# ES Service Information

SI0082  
New 4-04

Equipment Affected: YK Chillers

Software Enhancements Effective April 2004

FIG. 4

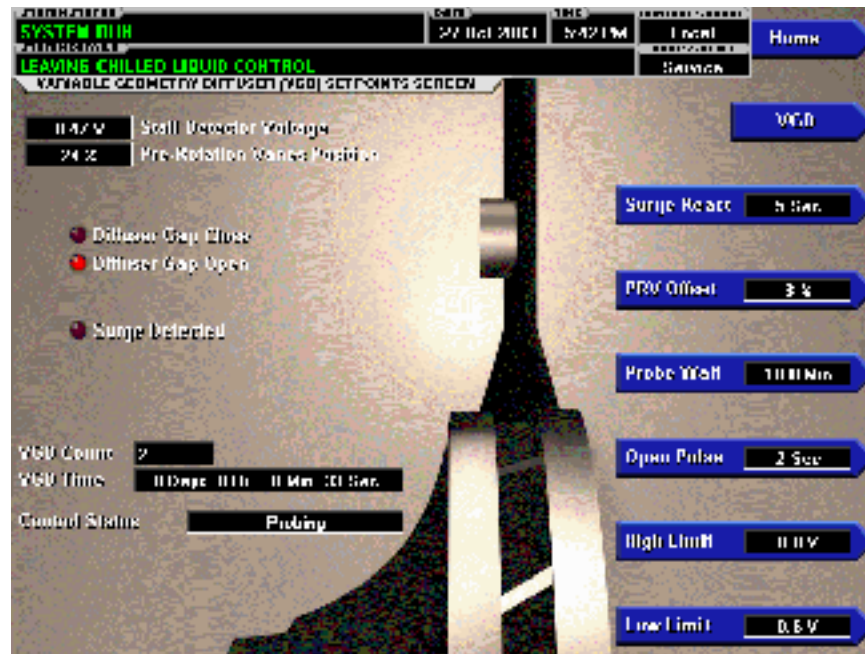
## VARIABLE GEOMETRY DIFFUSER SETPOINTS SCREEN

The Variable Geometry Diffuser setpoints are maintained on this screen. All setpoints require a login access level of Service. Service Technicians refer to YORK Service Manual 160.54-M1 for operation and explanation of all setpoints and displayed values.
